A d d e n d u m

Iowa Department of Transportation
Office of Contracts

B.O.	Proposal ID	Proposal Work Type	County	Project Number	Addendum
101	23-1415-620	PCC Sidewalk/Trail	Clinton	STP-E-1415(620)--8V-23	15nov101.a01

Make the following change to the Plan Sheet U.02:

CONCRETE STAIR UNIT

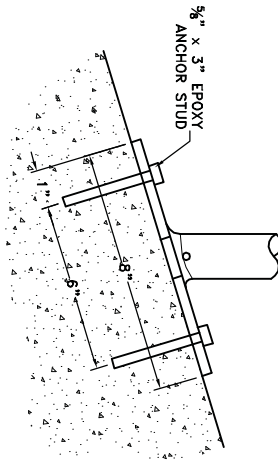
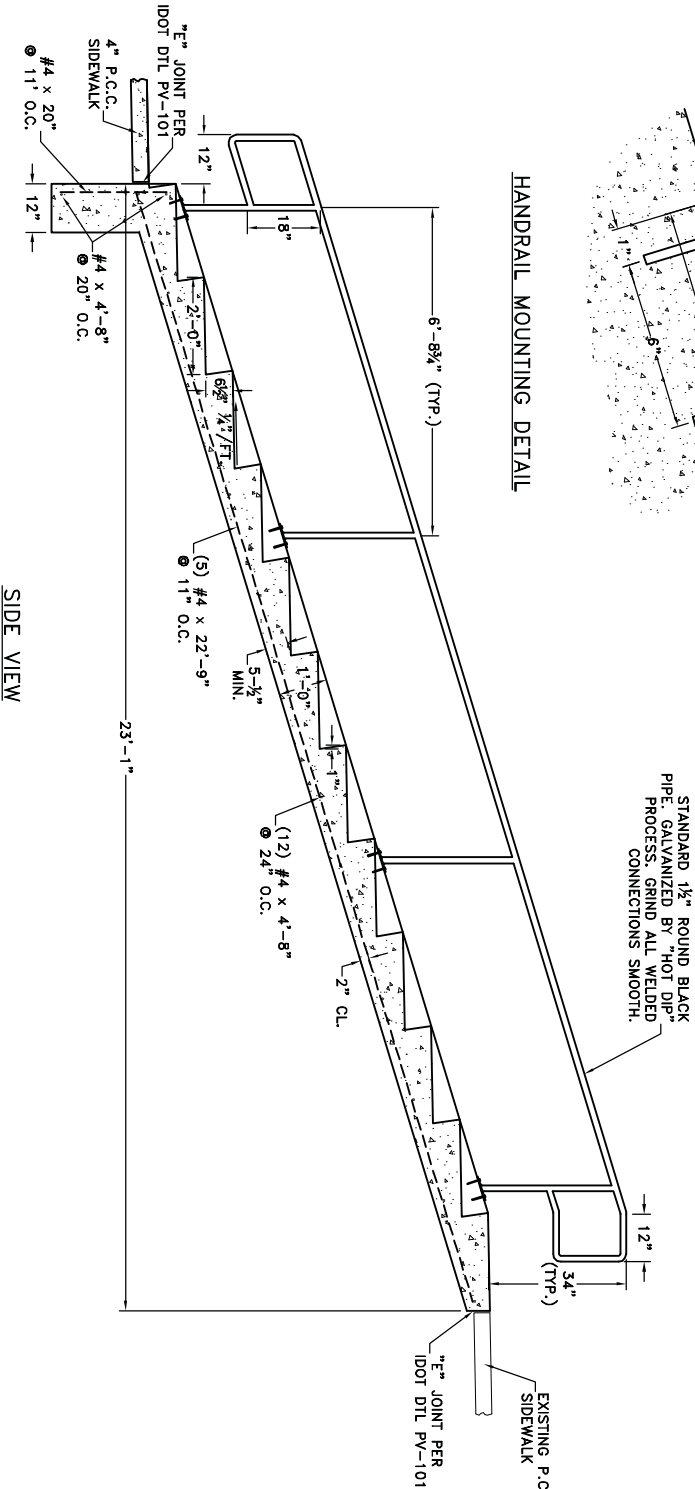
Replace: Concrete Stair Unit detail
With: Attached Concrete Stair Unit detail
